**METROPOLITAN DEVELOPMENT COMMISSION
HEARING EXAMINER**

STAFF REPORTS FOR MARCH 27, 2014

STAFF REPORT

Department of Metropolitan Development Division of Planning Current Planning Section

2013-MOD-016 – 'Parcel 2' Site Plan

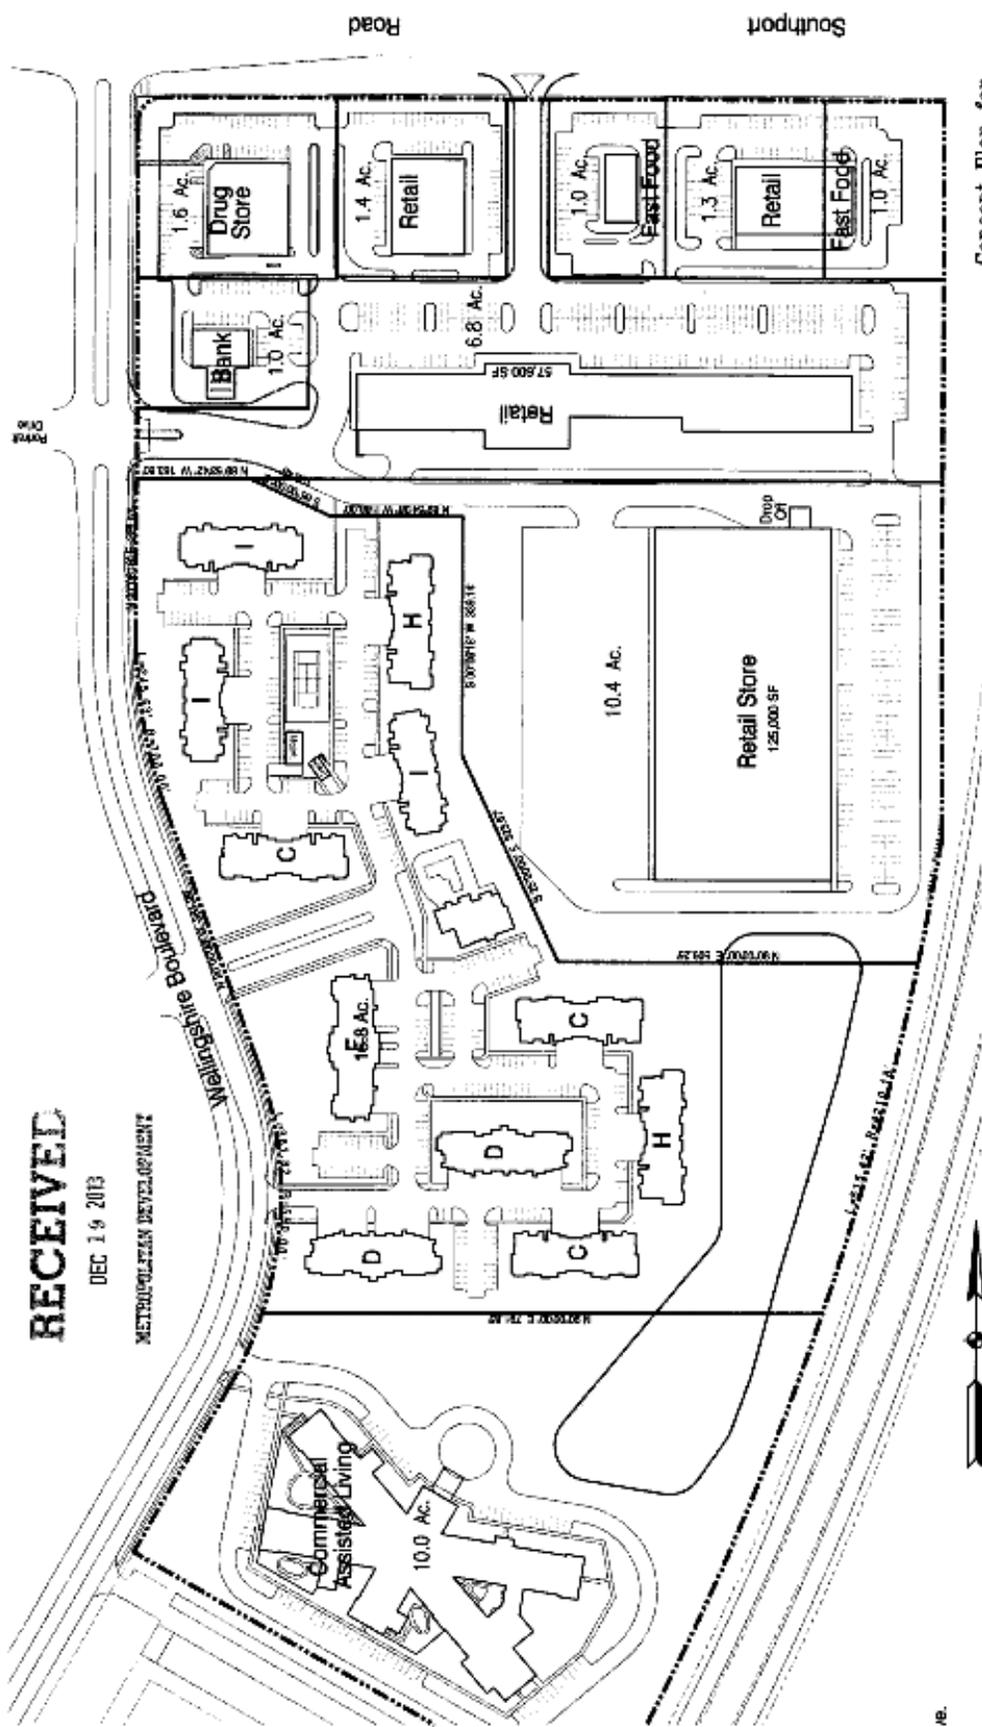
- ◇ The most significant change would be related to 'Parcel 2'. 'Parcel 2' is a 53-acre tract of land located immediately on the southwest corner of Southport Road and State Route 37. This tract is currently unimproved (Exhibit 3, 4). This area would be slated strictly for commercial development, up to 406,000 square feet, under the current development statement. This modification would change the allowed development within 'Parcel 2' to include up to 250,000-square feet of commercial, up to 400 multi-family dwelling units, and an assisted living facility.

- ◇ The preliminary site plan has been submitted, indicating the tentative layout of 'Parcel 2' (2013-MOD-016 – Proposed Parcel 2). The site plan continues to propose commercial uses near the intersection, with multi-family dwellings located south and west of the commercial uses. The assisted living facility would be slightly farther south.

Staff **recommends approval** of this request, subject to the Development Statement, file-dated December 19, 2013 and substantial conformity with the proposed concept plan, file-dated December 19, 2013.

SITE PLAN

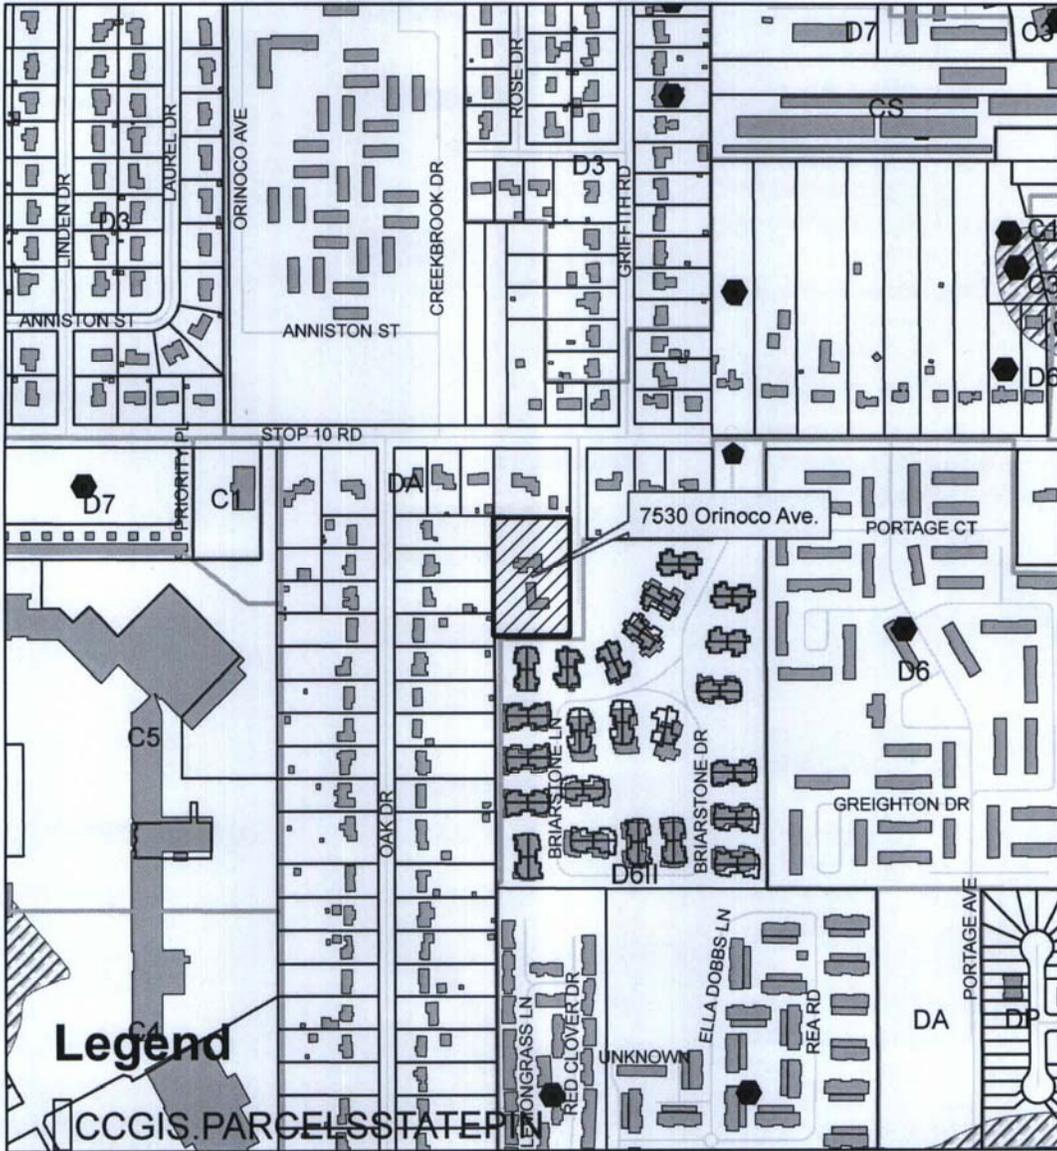
- ◇ As stated earlier, the existing 1,954 square-foot accessory building was constructed without permits. The total square-footage of all accessory buildings on site is 109.3% of the existing dwelling when only 75% is permitted. It was also constructed at a height of 20 feet, which is taller than the existing dwelling. The ordinance does not permit accessory structures to taller than the dwelling on a lot in order to keep them incidental and subordinate to the primary use of the lot.

- ◇ The existing lot is situated at the southern end of a dead-end street (Orinoco Avenue), which is public right-of-way that functions like a private driveway, only providing access to the subject site. The accessory buildings cannot be seen from Stop 10 Road so they don't have the appearance of being the dominate structure on the site. Additionally, the areas to the east, west and south contain substantial tree growth along the property lines, buffering the accessory buildings from the adjacent residential uses.

Staff **recommends approval** of the variance petition subject to the site-plan, file-dated December 18, 2013 and the following condition:

All required permits for the existing accessory building shall be obtained within 60 days of the variance grant.

2014-CZN/CVR-801 – Conceptual Plan

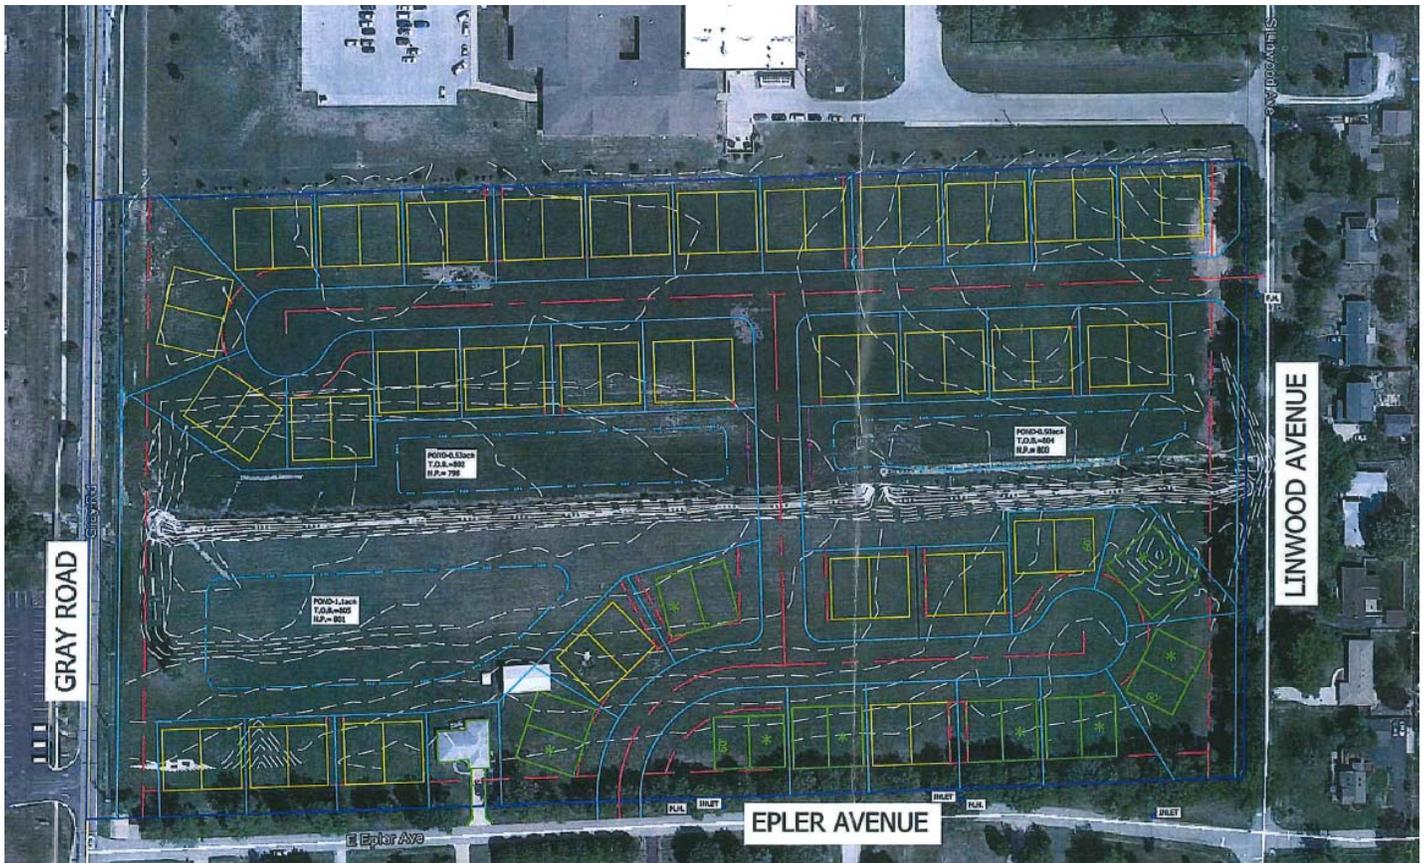
- ◇ In addition to the rezoning request, this request would also allow for lots within the development to provide open space below the 65% required by the D-5II District. Per the preliminary concept plan, the minimum amount of open space provided would be 48%, and some lots would provide open space above the 65% required by the Dwelling Districts Zoning Ordinance (DDZO).

- ◇ Considering that the decreased lot sizes would not result in densities exceeded the indexed plan recommendation, staff would not find this request to be objectionable. The petitioner has indicated that the lots would be marketed to individuals not wishing to maintain large lots.

- ◇ Mature trees are located on the southern and western borders of the subject site (Exhibits 2, 5). These trees provide inherent aesthetic and environmental value and should be preserved where possible. To this end, a tree preservation plan should be submitted for Administrator’s Approval, prior to the approval of a final plat or any site preparation activity.

- ◇ The Subdivision Control Ordinance would require sidewalks within the proposed development and along the Epler Avenue, Gray Road, and Linwood Avenue frontages. The area where sidewalks would be installed, in certain areas, may interfere with the aims above related to tree preservation. The location of proposed sidewalks should be sensitive to this issue, and a sidewalk plan shall be submitted prior to the approval of a final plat. Depending on the location of the proposed sidewalk vis-à-vis the location of proposed trees, pedestrian access easements may be necessary in areas where the proposed sidewalk would be best located on private property.

1. Prior to a final subdivision plat being recorded and prior to any site preparation activity, a tree preservation plan shall be submitted for Administrator's Approval. The tree preservation plan at minimum: a) delineate the location of the existing mature, healthy, non-invasive trees, b) characterize the size and species of such trees, c) indicate proposed development, and d) identify the method of preservation (e.g., provision of snow fencing or staked straw bales at the individual tree's dripline during construction activity). All trees proposed for preservation shall be indicated as such, and all development shall be located in a manner which causes the least amount of disruption to the trees.

2. Prior to a final subdivision plat being recorded and prior to any site preparation activity, a sidewalk plan shall be submitted for Administrator's Approval. The sidewalk plan shall indicate the proposed location of sidewalks and existing trees to be preserved. If it is determined by the Administrator that sidewalks located on private property would be required to achieve the tree preservation aims established by Commitment One (1), pedestrian access easements shall be executed and recorded as necessary.

2014-CAP/CVR-804 – Site/Landscape Plan

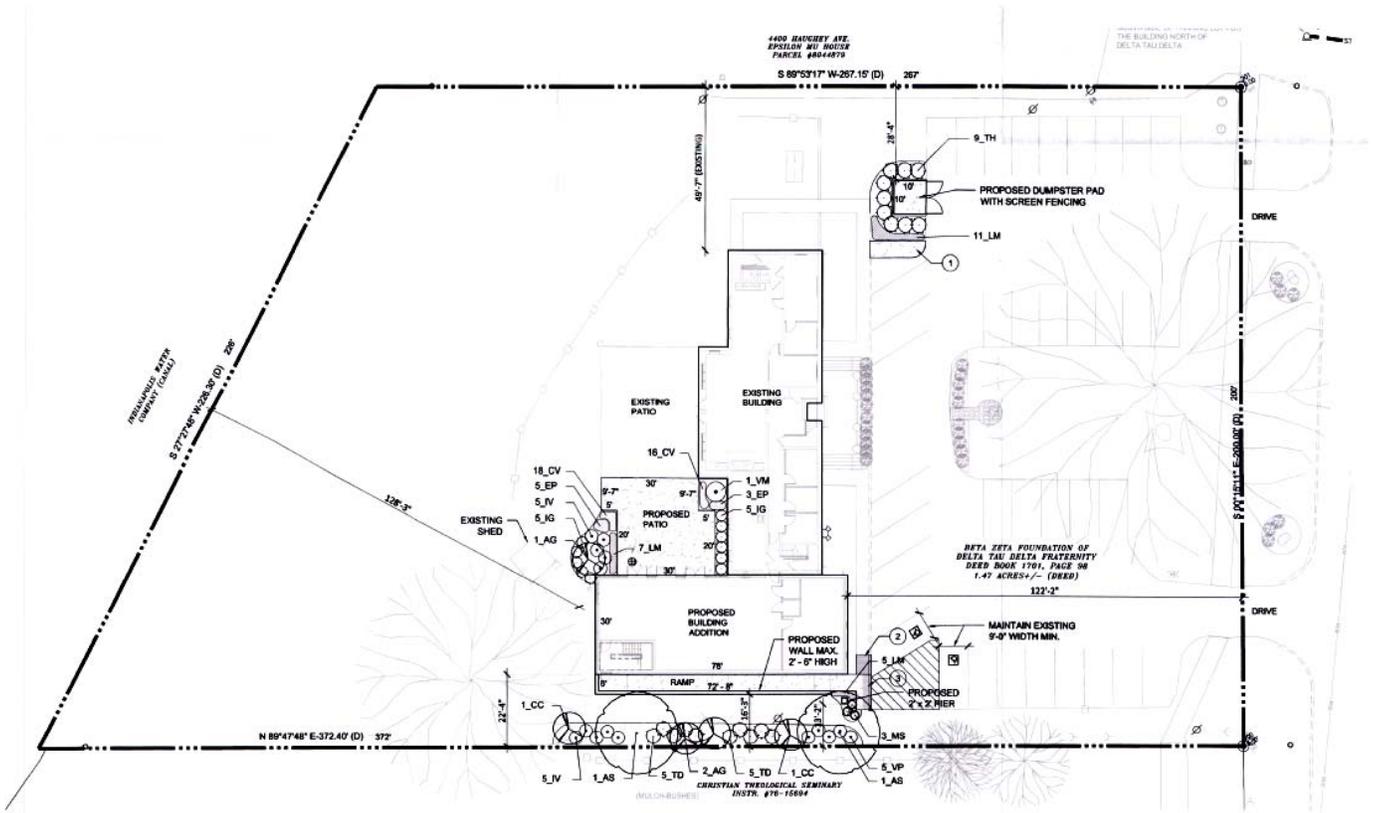
- ◇ This request would provide for a three-story building addition, located to the south of the existing structure. The addition's footprint would be approximately 2,340 square feet, with a total of 7,020 square feet within the three-story structure (2014-CAP/CVR-804 – Site Plan). Additional improvements would include an accessibility ramp, located south of the new addition and a new patio area, just less than 900 square feet north of the new addition and west of the existing building.

- ◇ The petitioner has indicated the new addition would provide additional housing for approximately 30 tenants, for a total of approximately 60. 36 parking spaces are indicated on the site plan. 60 tenants would likely create a demand approaching 60 parking spaces, though it is possible that some tenants would not have personal vehicles, lessening this demand somewhat.

Staff **recommends approval** of this request, subject to the site and landscape plan, file-dated February 13, 2014, and the elevations, file-dated February 13, 2014.
